02.00 CONSENTED VS. PROPOSED DRAWINGS
02.07 (NORTH) EAGLE STREET ELEVATION

Planning Application 2020/1350/P

Planning Application 2021/3561/P

02.11 SECTION BB

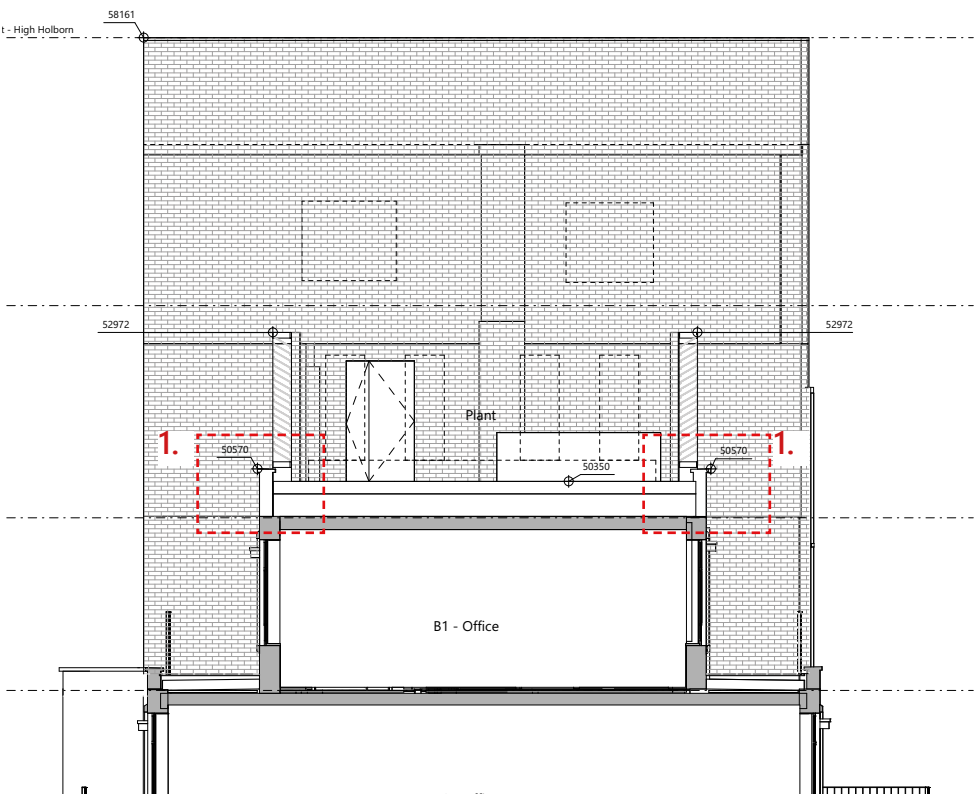
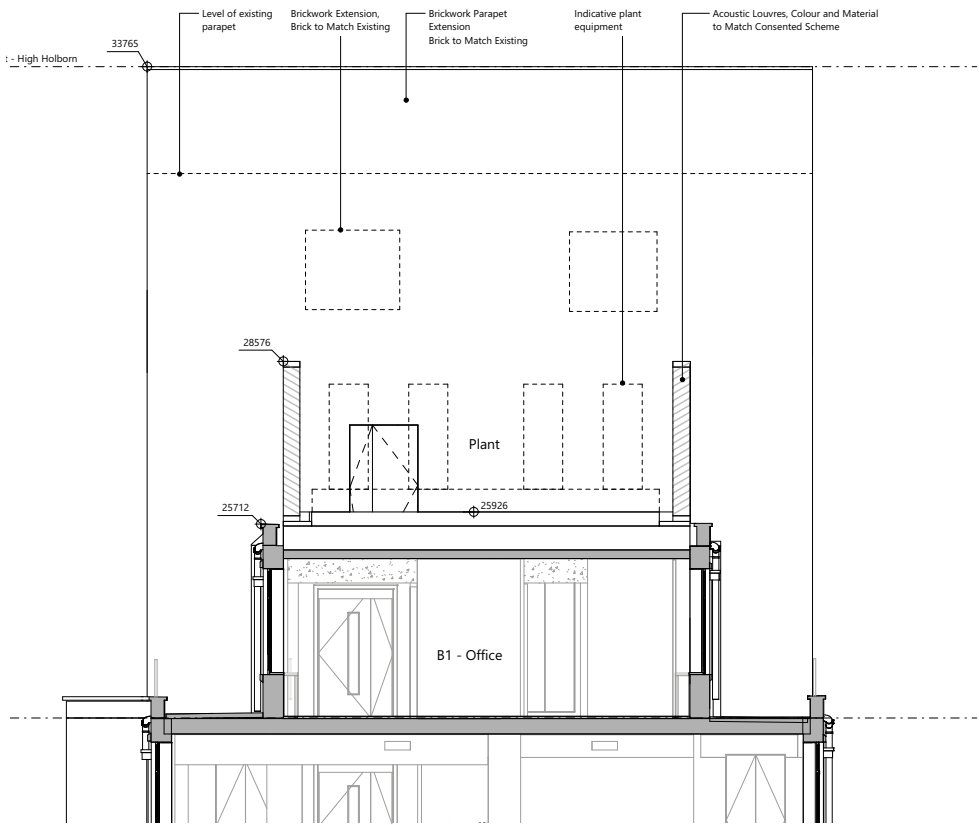
1. Parapet of link block roof extended to accommodate overall roof build up (strengthening of existing slab and insulation for improved thermal performance). Brick to match existing.

02.00 CONSENTED VS. PROPOSED DRAWINGS
02.12 SECTION CC

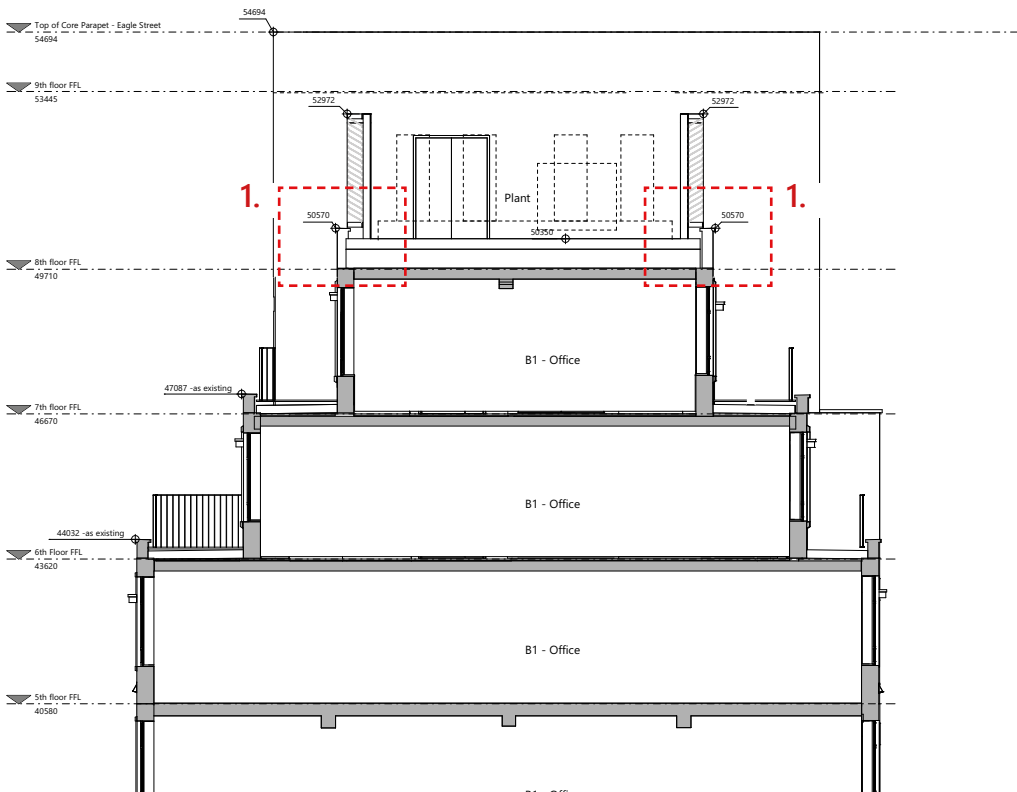
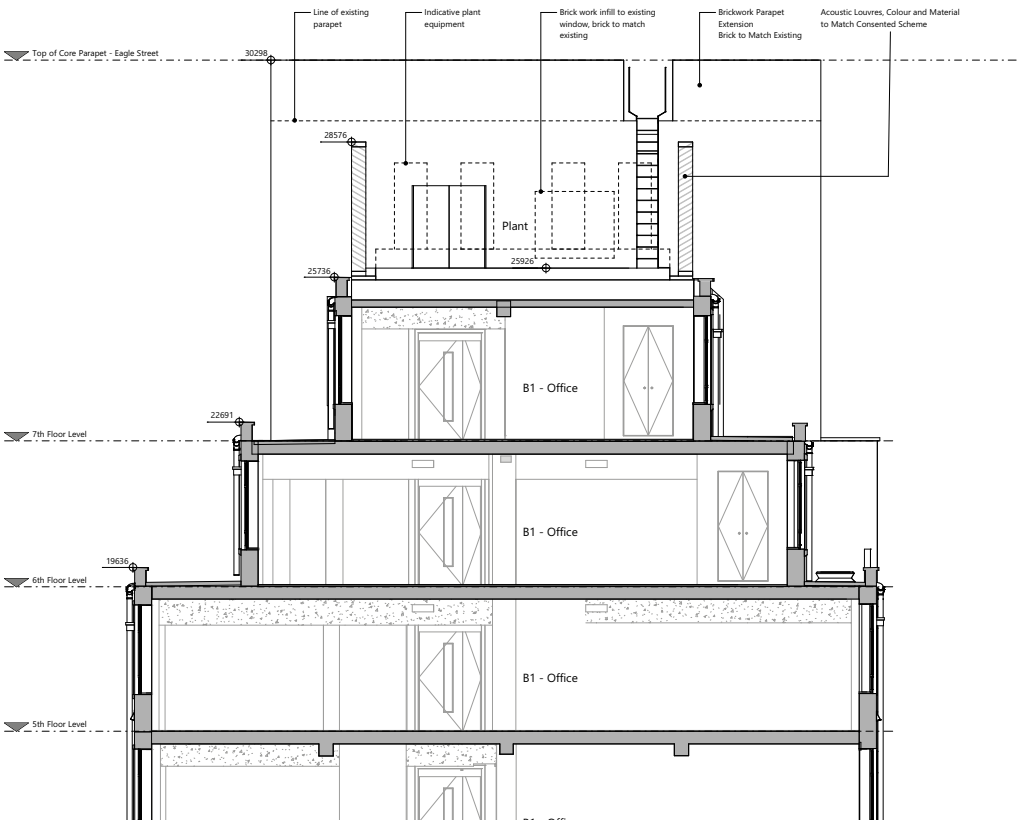
- 1. Parapet of link block roof extended to accommodate overall roof build up (strengthening of existing slab and insulation for improved thermal performance). Brick to match existing.

02.00 CONSENTED VS. PROPOSED DRAWINGS
02.13 SECTION DD

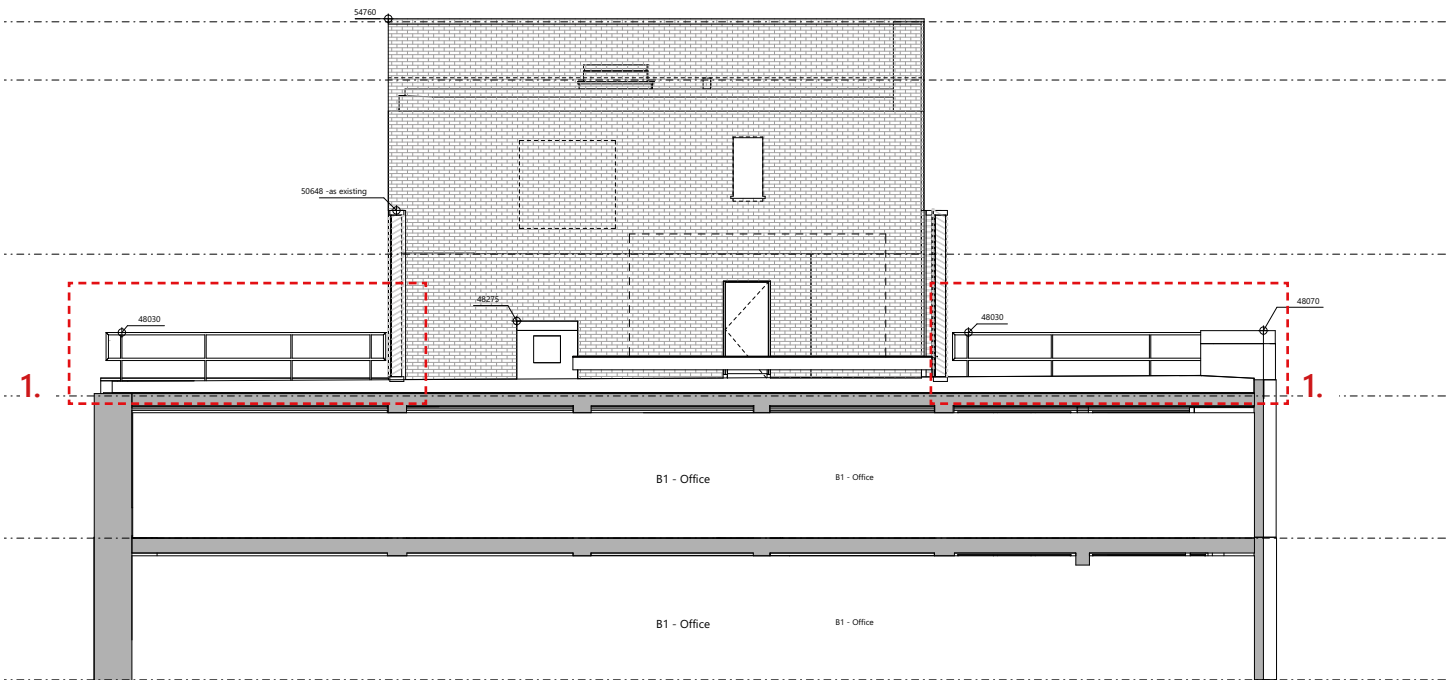
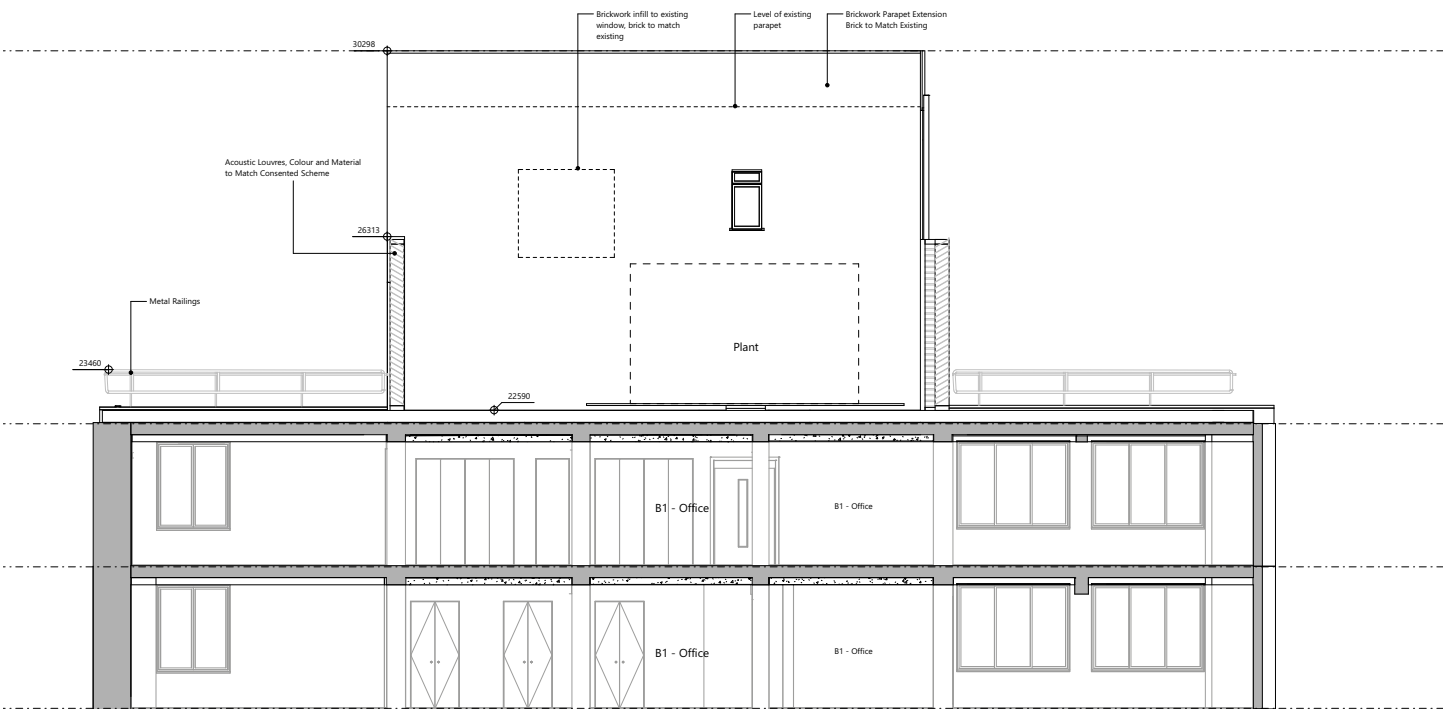
1. Replacement railing to match existing. In order to comply with Part L building regulations, all roofs will receive new coverings which will improve their thermal performance. The consequent increase in the roof build up means that the railings will no longer be Part K compliant as they will be less than 1.1m above external finish floor level. As the existing railings do not guarantee safe access to the roofs, the proposal is to replace these by new ones which will rise a least 1.1m above the external roof level.

02.14 SECTION EE1

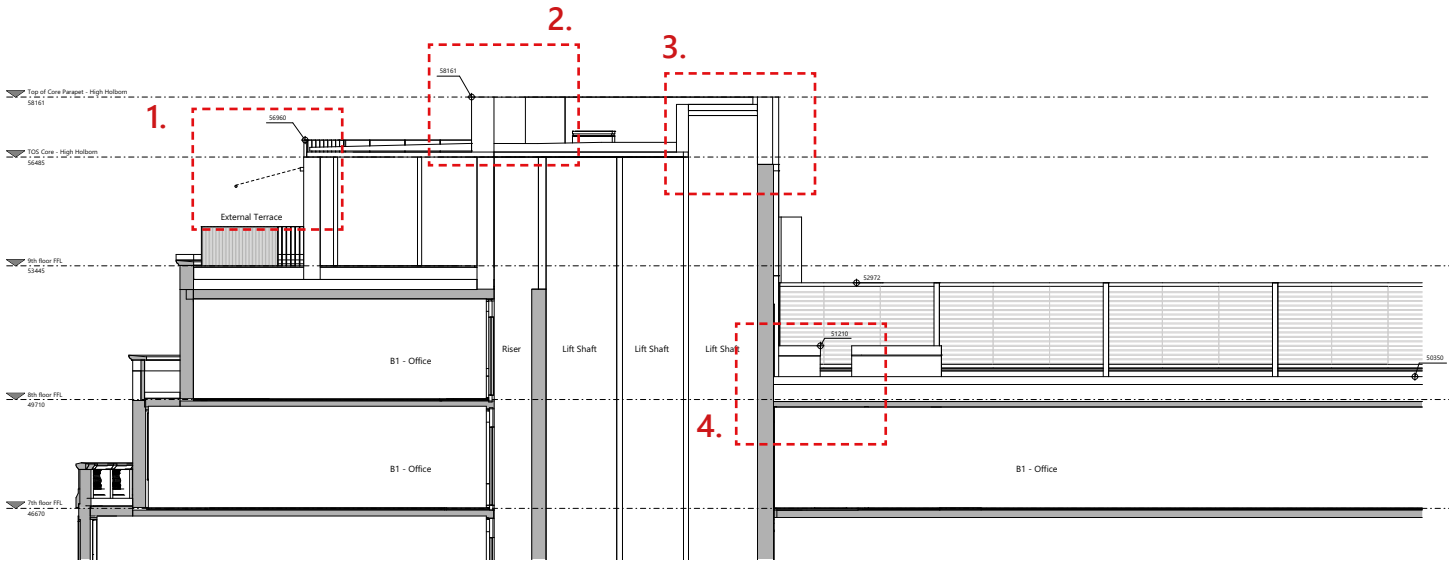
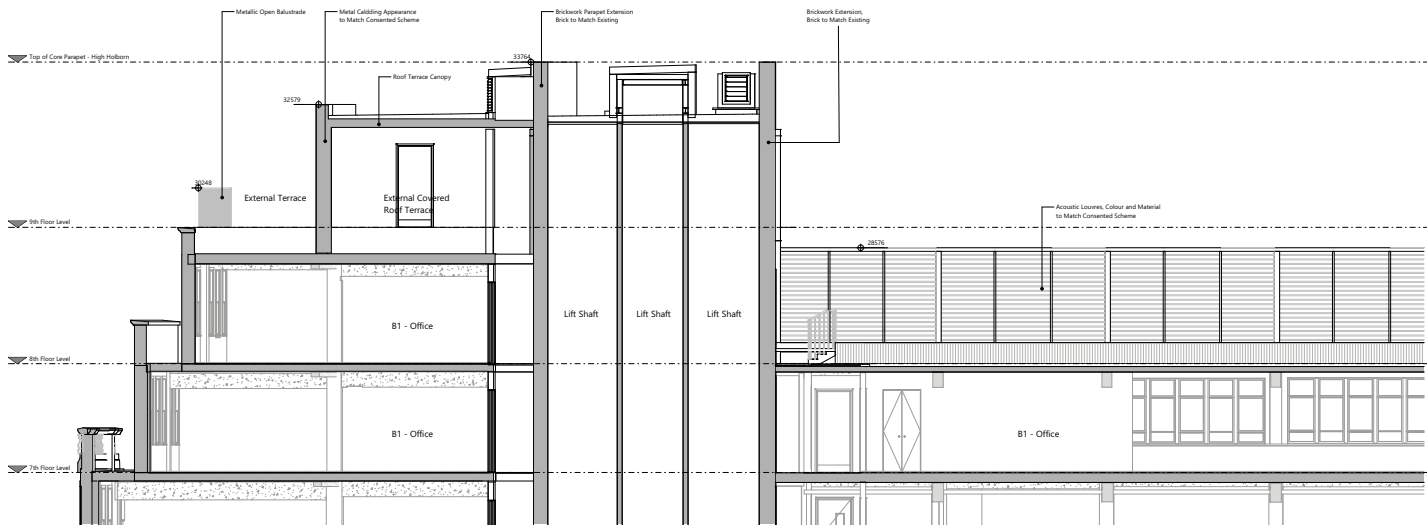
- 1. Retractable awnings proposed to the whole extent of the covered terrace, including pergolas.
- 2. Riser up stand reduced and louvres at high level omitted.
- 3. Lift overrun location amended.

- 4. Stairs from High Holborn core into the Link Block plant area omitted. Level change to happen on the inside.
